Addendum 3

Project: Hamilton-Wentworth District School Board
REFERENCE NO. 2025-107-P02082
Hess Street Elementary School Ground Floor Ceiling Replacement and
Lobby / Classroom Renovation Project

Addendum No. 2

Project: HWDSB-P2024-2082 – Hess Street ES Renovation

Drawing E3-00

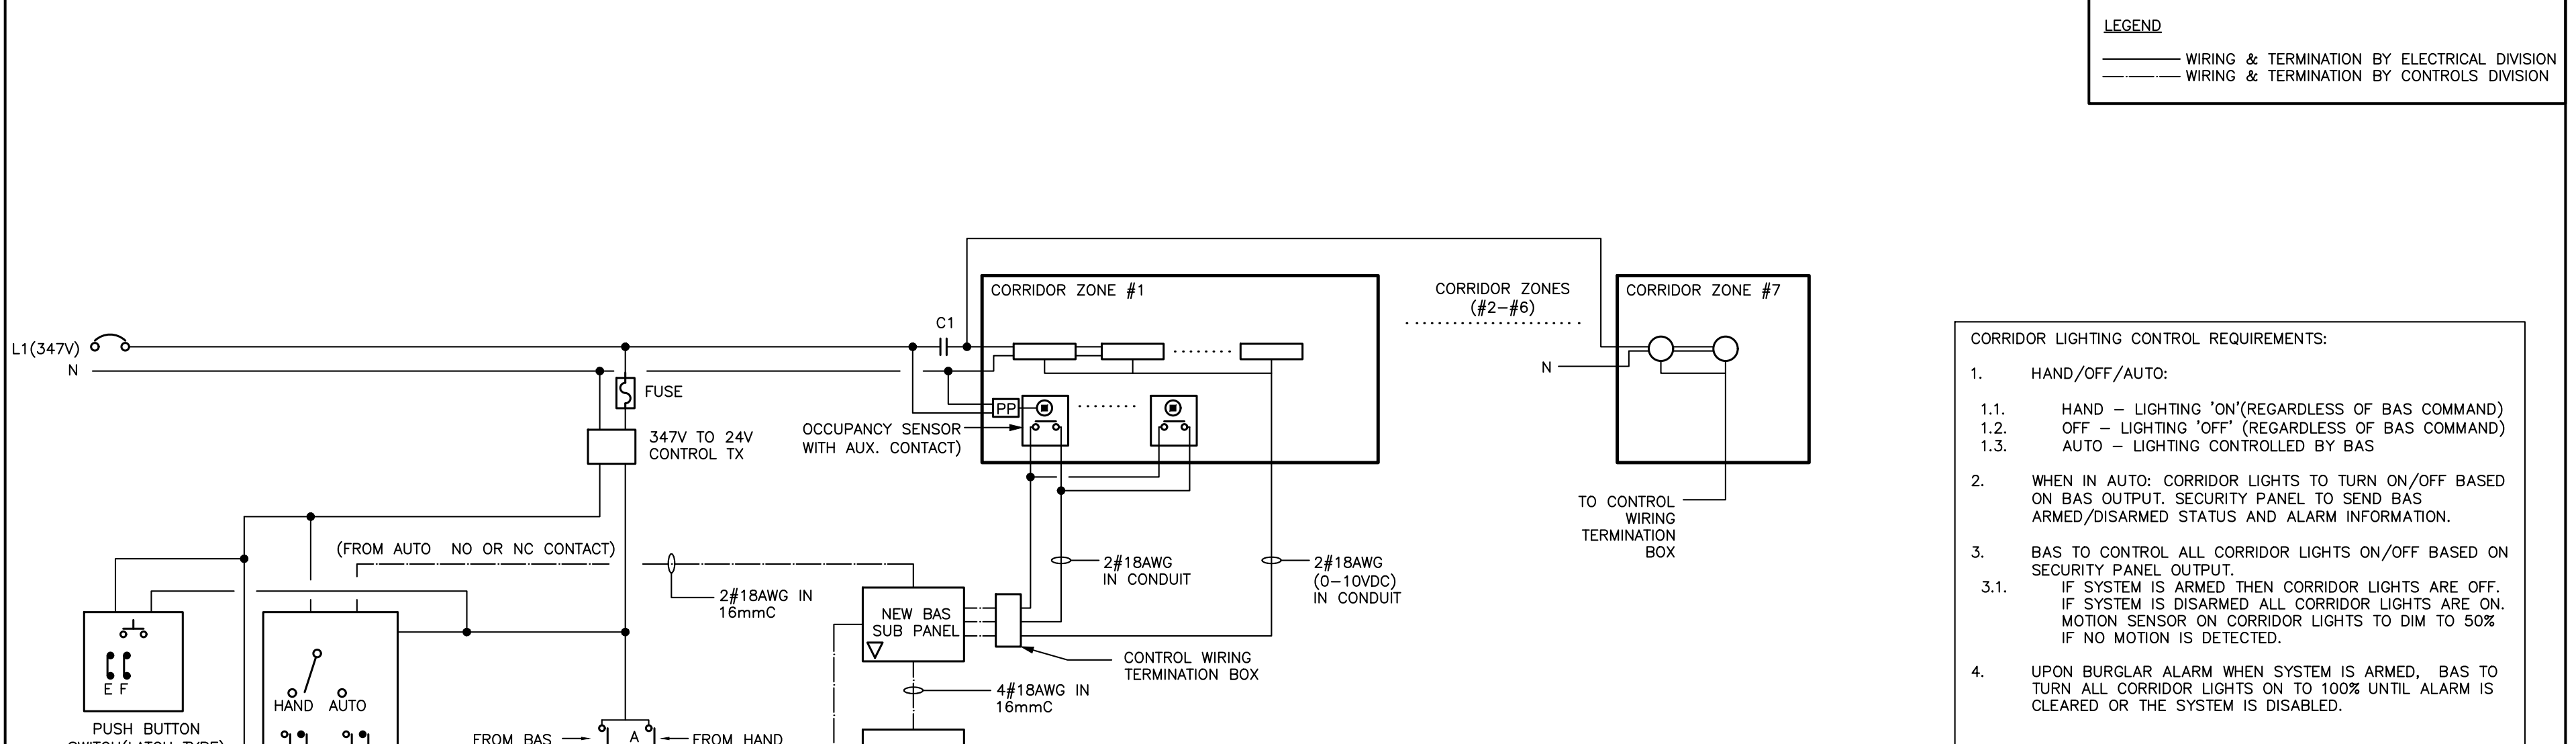
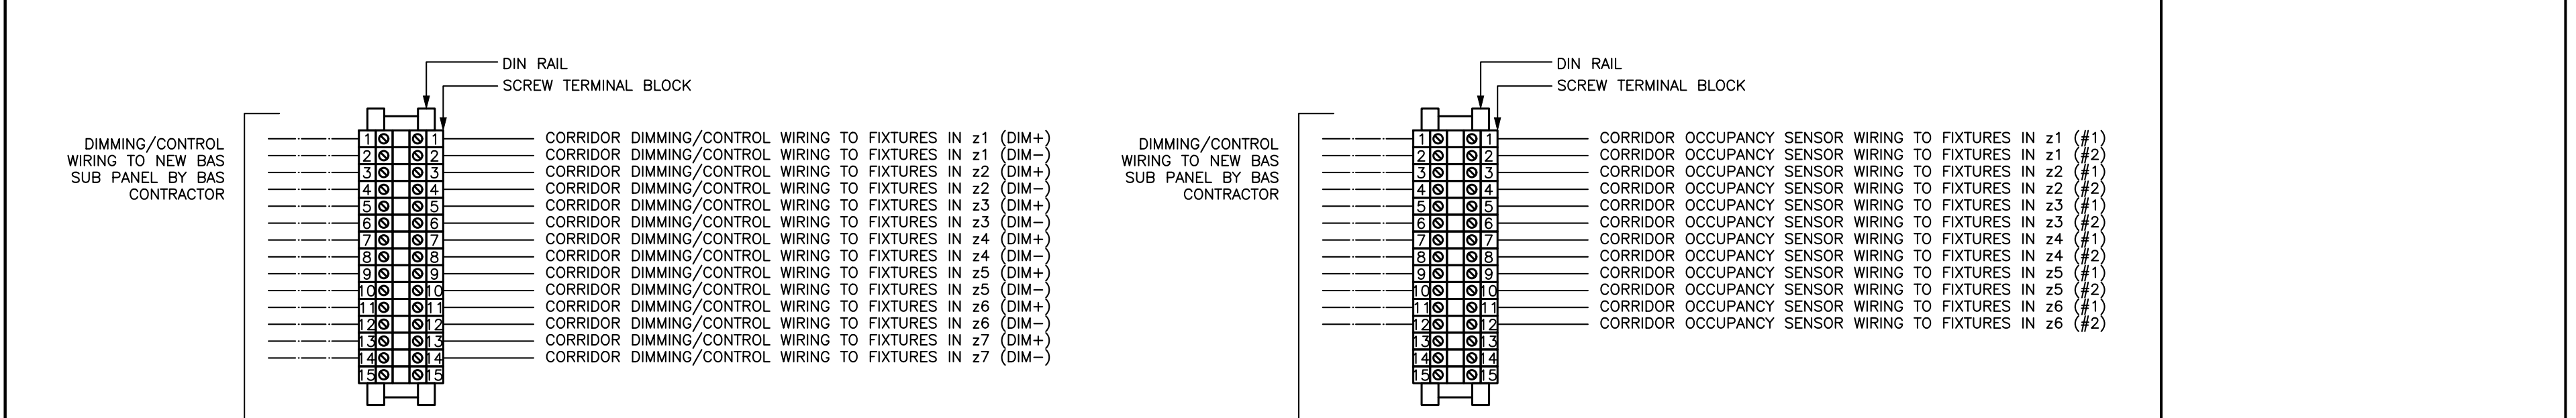
9. **ADD** Corridor/Lobby lighting detail as shown.

| | Project Title : Hamilton District School Board P2024-2082 Hess Street Elementary School Ceiling Renovation, 107 Hess Street North Hamilton, Ontario | Drawing Number : MSK-01 ⁰ |

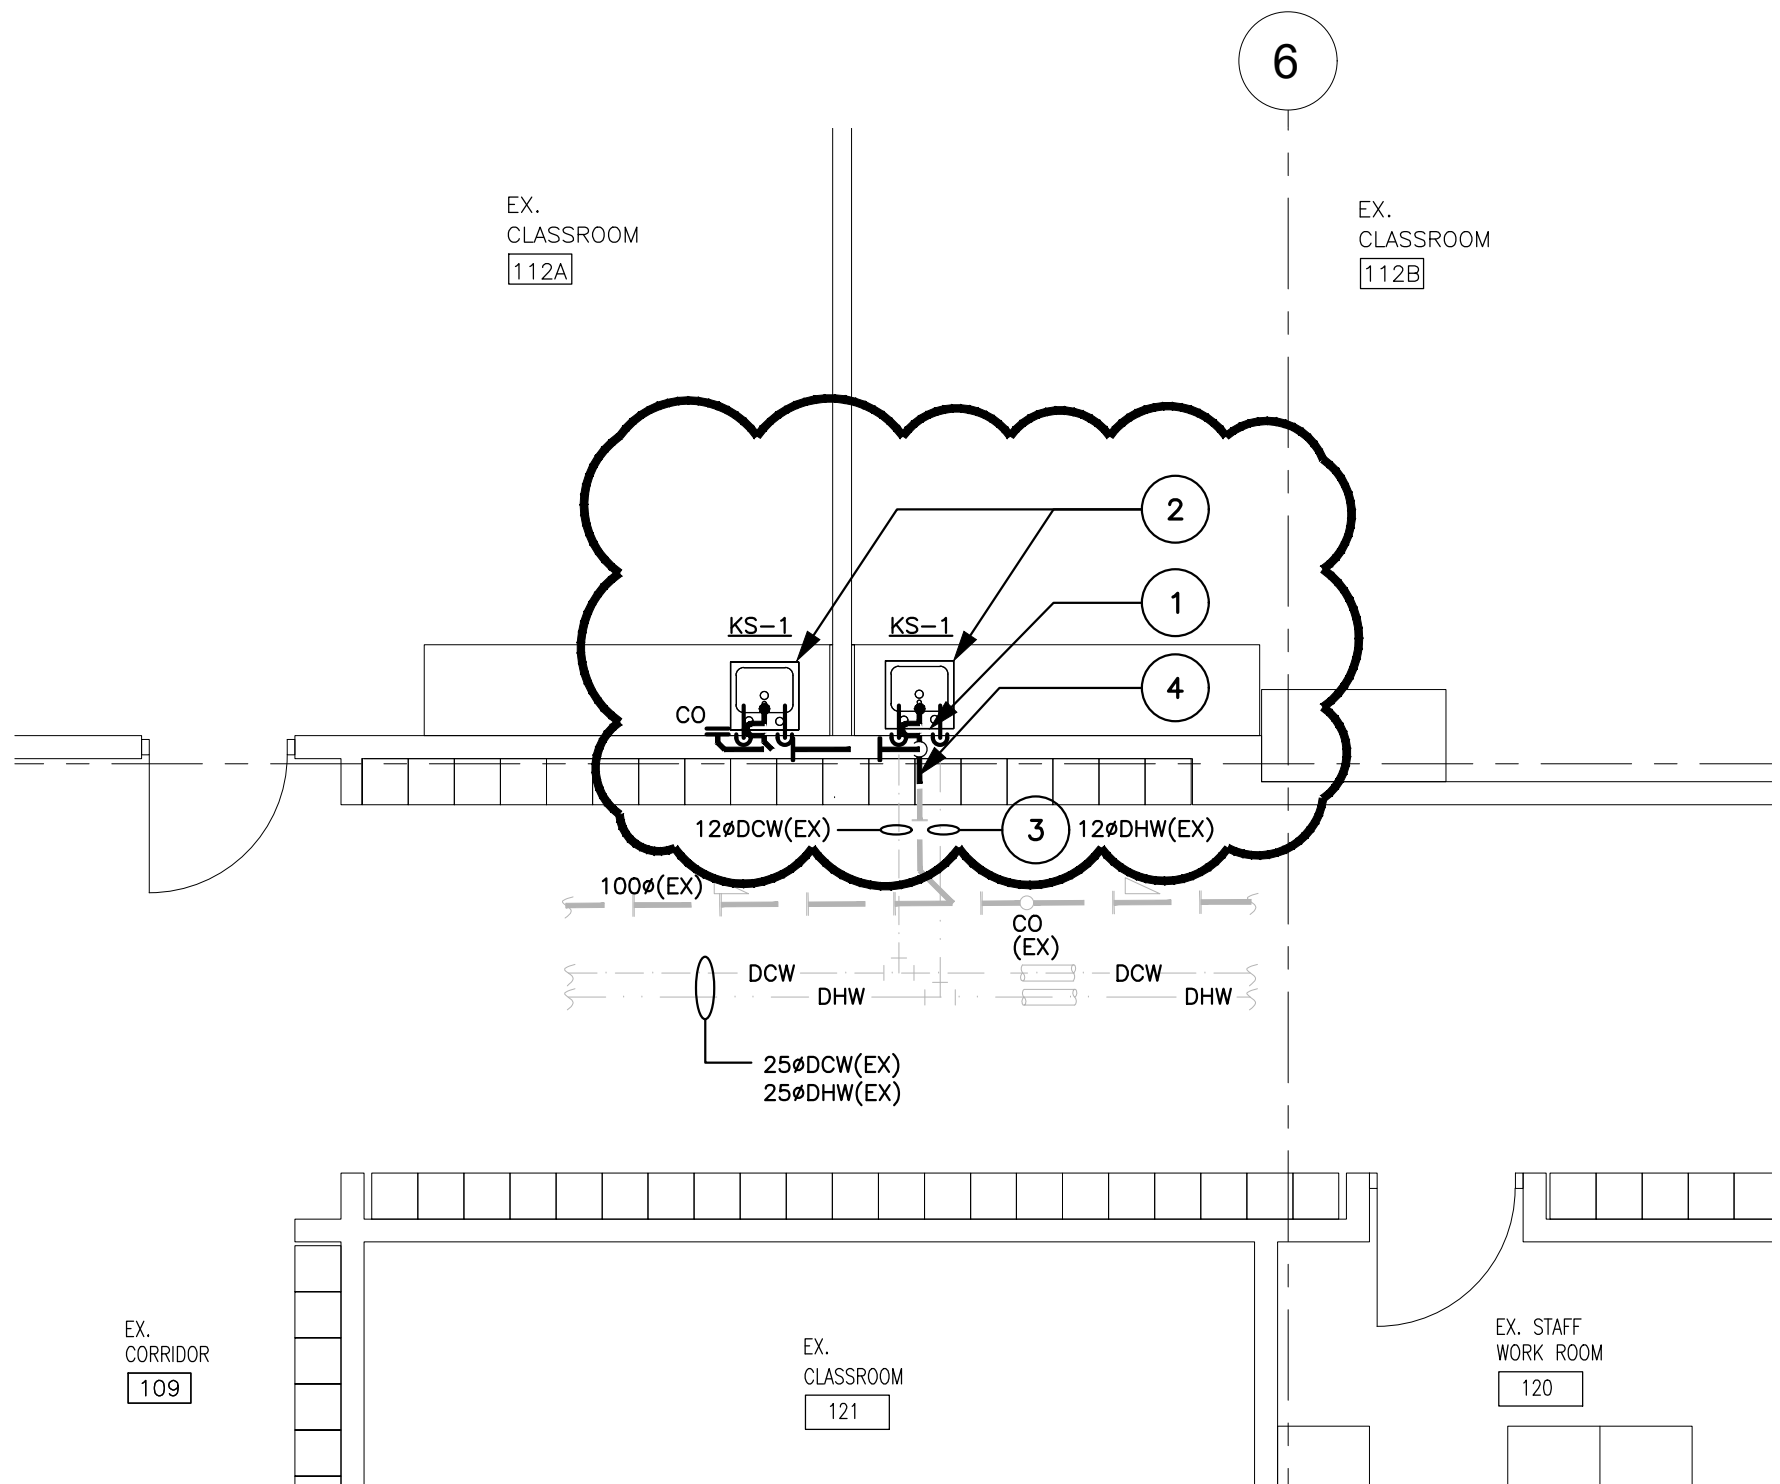
1. **INCLUDE** in price for all the required roof cones for the Gymnasium HVAC unit. **INCLUDE** a dedicated roof cone for the BAS wiring.
2. **REMOVE** existing sink and add two sinks as shown on attached sketch MSK-01.

- 1 DEMOLISH EXISTING SINK.
- 2 RUN NEW DCW/DHW FROM UNDERSIDE OF THE EXISTING SINK TO NEW SINKS. ALL PIPING SHALL BE HIDDEN INSIDE EXISTING WALL AND RUN INSIDE CEILING SPACE.
- 3 THE PIPE SIZES SHOWN ARE APPROXIMATE, FIELD VERIFY AND INFORM CONSULTANTS IF DIFFERENT.
- 4 FOR SANITARY PIPES ALLOW FOR FLOOR CUTTING, EXCAVATION, BACKFILLING, DOWELING AND RESURFACING/ NEW SLAB TO MATCH EXISTING FLOOR COLOR AND TYPE INCLUDING REPLACEMENT OF NEW FLOORING.
